Access Compliance Report

Public Rights-of-Way

(Curb Ramps)

Intersection ID: 49323	Main Street: CLIFTON_MEADOW_DR	Cross Street: WHITEBEAM_WY	Location: SW
ADA ID: 1A684645735B	Ramp Type: PerpDiag	Initial Pass/Fail: Fail	Overall Compliance: No
Severity Score: 46.25			
Codes/Mitigation Info/Possible Solution		Field Measurements/Component Compliance

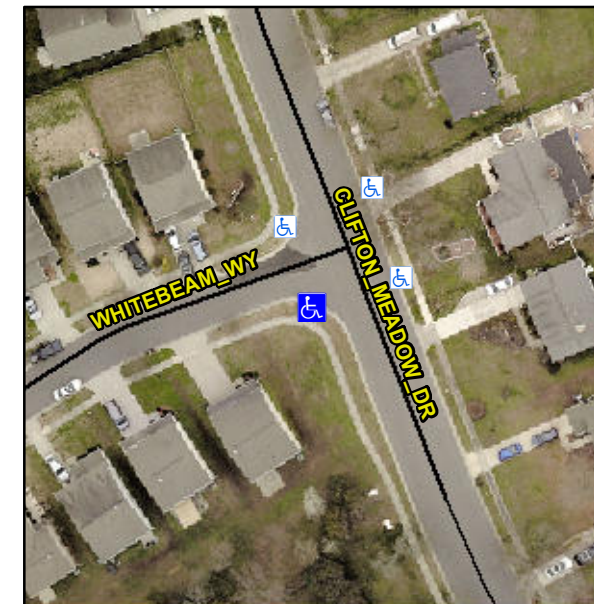
Not Found, R304.5.1, R304.2.2, R304.5.3

Compliance	Description	Data	Compliance	Description	Data
N/A	Ramp Length (in)	68.0	No	Ramp Slope (%)	8.8
No	Ramp Width (in)	47.0	No	Ramp XSlope (%)	9.8
N/A	Flare Type LT	N/A	N/A	Flare Type RT	N/A
N/A	Flare Slope LT (%)	N/A	N/A	Flare Slope RT (%)	N/A
N/A	Flare Traversable LT?	N/A	N/A	Flare Traversable RT?	N/A
N/A	Landing Length (in)	N/A	N/A	DWS Provided?	N/A
N/A	Landing Width (in)	N/A	N/A	DWS Contrast?	N/A
N/A	Landing Slope (%)	N/A	N/A	DWS Length (in)	N/A
N/A	Landing X Slope (%)	N/A	N/A	DWS Full Width?	N/A
N/A	Landing Curb? (Y/N)	N/A	N/A	DWS Offset (in)	N/A
N/A	Shared Landing?	N/A			
N/A	Gutter Ponding?	N/A	N/A	Gutter Slope (%)	N/A
N/A	Gutter Lip Ht (in)	N/A	N/A	Gutter X Slope (%)	N/A
N/A	Painted X Walk1?	No	N/A	Painted X Walk2?	No
	X Walk 1 Direction	To E		X Walk 2 Direction	To N
N/A	X Walk 1 Width (in)	N/A	N/A	X Walk 2 Width (in)	N/A
	X Walk 1 Slope (%)	9.3		X Walk 2 Slope (%)	2.7
	X Walk 1 X Slope (%)	1.2		X Walk 2 X Slope (%)	7.4

N/A	Ramp inside XWalk1?	N/A	N/A	Ramp inside XWalk2?	N/A
	Road Slope (%)	9.4	N/A	Clear Space?	N/A
	Road X Slope (%)	5.4	N/A	Clear Space to XWalk (in)	N/A
N/A	Any Obstructions?	N/A	N/A	Storm Grate/Utility Hazard?	N/A
	Obstruction Type			Storm Grate/Utility Type	
		N/A			N/A
			Yes	Surface Condition? (G/P)	Good

Remove & Replace Curb Ramp With Two New Directional Ramps or Equivalent.
